N900040100

Item Name: Baggage Compartment Protector Wall

DART SERVICE INSTRUCTION

TO AMEND INSTALLATION INSTRUCTIONS IIN-D407-781-2 REV. A OR LATER APPROVED REVISION
AND INSTRUCTIONS FOR CONTINUED AIRWORTHINESS ICA-D407-781 REV. 3 OR LATER REVISION

**FIGURE 1 - D3879-1 BAGGAGE COMPARTMENT WALL
PROTECTOR - ALTERNATE INSTALLATION**

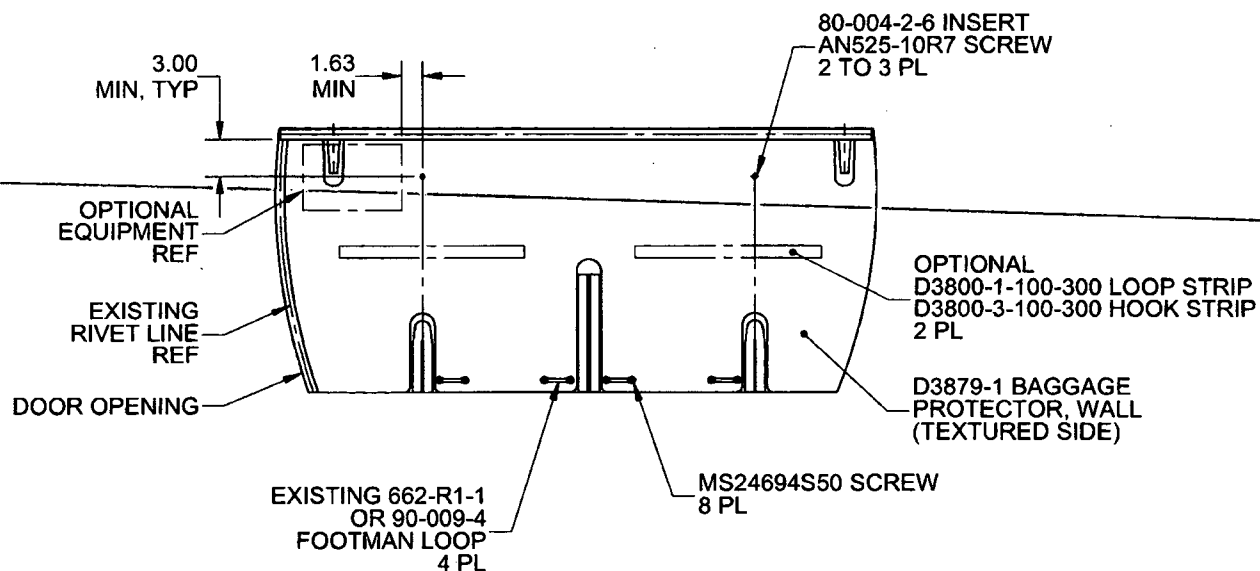
In some aircraft, the top portion of the D206-781-041 Baggage Compartment Wall Protector Kit cannot be installed as indicated in IIN-D407-781-2. The purpose of this DSI is to provide an alternate mounting method to fasten the top portion of the D206-781-041 Baggage Compartment Wall Protector Kit.

It is acceptable to replace qty(2) D3930-1 Clips with qty(2) 80-004-2-6 Inserts. Locate and mark location of the two attachment holes on the baggage compartment wall as shown in Figure 1 of this service instruction. Install 80-004-2-6 Inserts at the marked locations in accordance with Section 3-2-12 of BHT-206-SRM-1. It is acceptable to trim the wall protectors to accommodate optional equipment or transfer attachment holes to the wall protector and install the optional equipment on top of the wall protector with longer fasteners.

Amend the D206-781-041 Baggage Compartment Wall Protector Kit parts list as follows:

Qty -061	Qty -031	Qty -041	Part Number	Description
X			D206-781-061	BAGGAGE COMPARTMENT PROTECTOR KIT (FLOOR AND WALL)
1	X		D206-781-031	BAGGAGE COMPARTMENT FLOOR PROTECTOR KIT
1		X	D206-781-041	BAGGAGE COMPARTMENT WALL PROTECTOR KIT
		2	AN525-10R7	SCREW
		2	80-004-2-6	INSERT
